City Planning Commission
Sacramento, California

- SUBJECT: A. Negative Declaration
- B. P86-107, Special Permit for 25 percent density bonus for senior citizens housing time extension of one year.
- C. P86-197, Variance to reduce the required parking from 109 to 55 spaces

LOCATION: 2360 and 2400 Northview Drive

Re: Plan Review P86 107
Birnam Woods Senior Housing

SITE PLAN

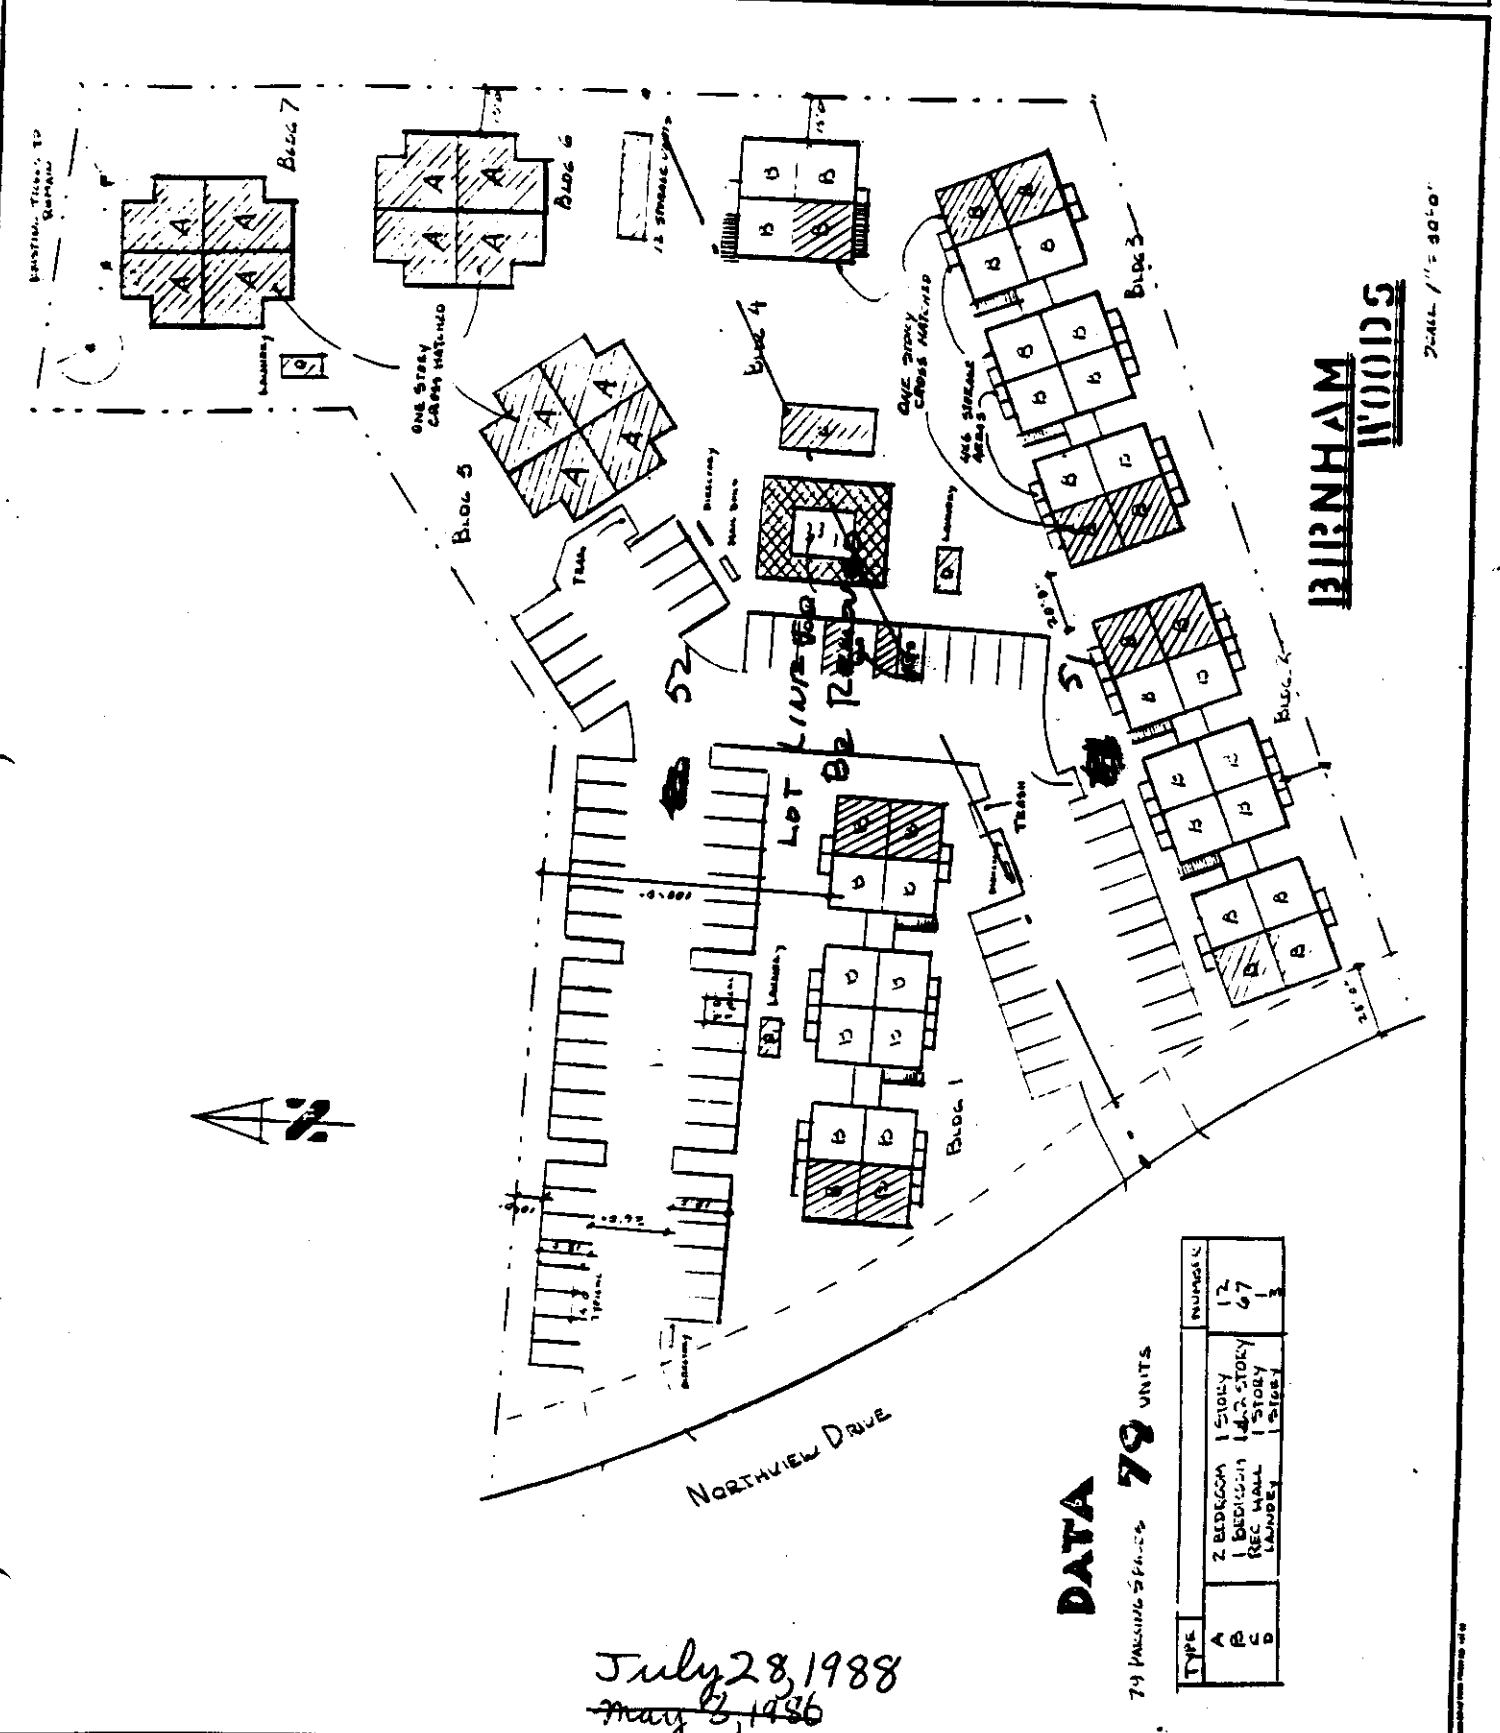
The parking area is not covered. Staff recommends that 75% of the parking spaces be covered. Since the Commission has approved parking ratio's from 0.7

The site plan does not indicate the location and type of trash enclosures to be used for this project. Staff recommends the applicant submit detailed plans for the enclosures using guidelines in Exhibit C.

5. Some of the units are too far from parking. The site plan should be redesigned to accomodate immediate adjacency of parking to the units based on the proposed senior housing use.

- *13. A minimum of 50% of the units shall be 500 square feet of area or larger. (staff added)
- *14. Revise site plan to provide parking closer to the easterly units. (staff added)

ELEVATIONS

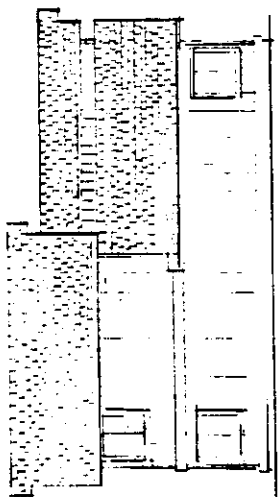
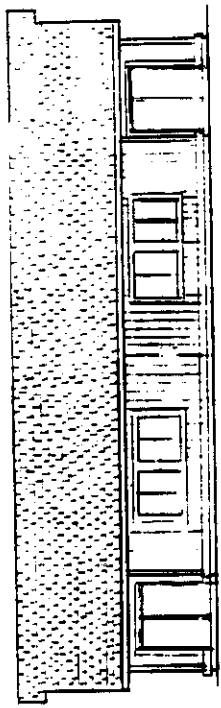
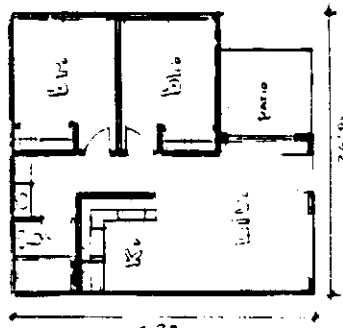
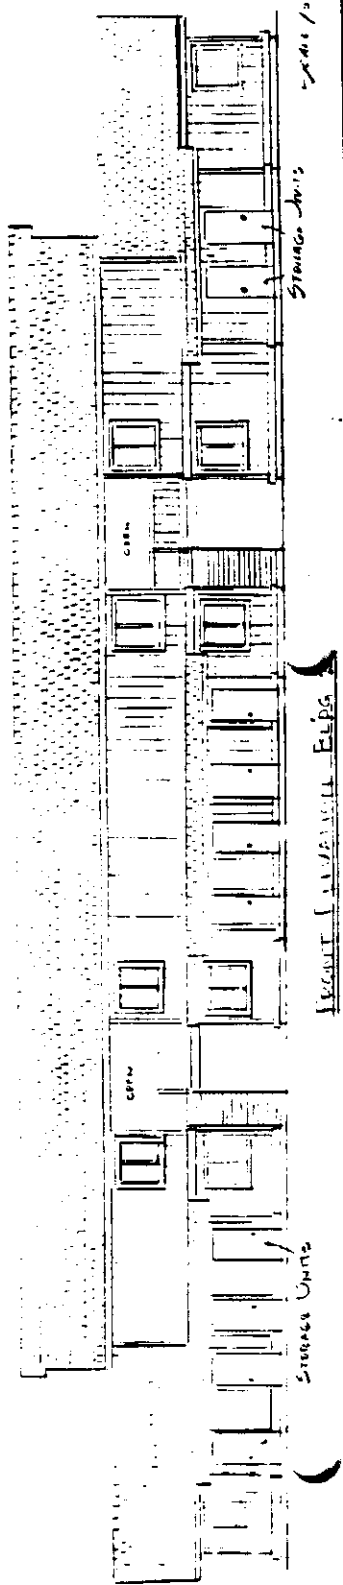
The proposed building elevations indicate use of vertical T1-11 exterior wood siding with a composition shingle roof. Horizontal treatment will be provided by masonite siding. Staff is concerned with the long block of building mass along the central portion and south property line (see elevation plan). More variation could be designed into the cluster buildings by breaking up the roof line with vertical walls or different roof planes. Addition of windows in blocks of walls and end elevations would also provide relief in the wall planes. Staggering the footprints of each four unit, six unit or eight unit structure so that variable setbacks are shown would also provide relief. Staff recommends these modifications be reflected on revised site plans and elevations.

2. The buildings are the same unimaginative trash we have consistently worked to eliminate from our community. The use of T-1/11 siding, the lack of surface articulation and fenestration, and the lack of any sensitive massing and scale are typical of the building design elements we object to. The two buildings at the south side of the site are 140' long with a separation of only 20'. These buildings will read as a single building 280' long, a situation that is unacceptable. This design appears to be worse than government designed housing.

9. The applicant shall submit revised elevations for Planning Director review and approval prior to issuance of building permits. Elevation plans shall include the following:

- a. Delete the 5/8" grooved plywood on exterior surfaces.
 - b. Building materials shall consist of masonite lap siding and stucco with heavy composite shingle roofs;

- c. Carports shall be designed with materials that are compatible with the apartment structures;
 - d. End elevations shall be modified to provide relief and interest by adding additional windows;

- e. Second floor patios shall have solid railings/barriers and a roof placed over a portion of the patio.
- f. Use decorative entry doors.
- 10. A sign program for the complex, including identification signs and interior directional signs and maps, shall be submitted for staff review and approval prior to issuance of sign permits. The sign program shall conform to the attached Residential Design Criteria.
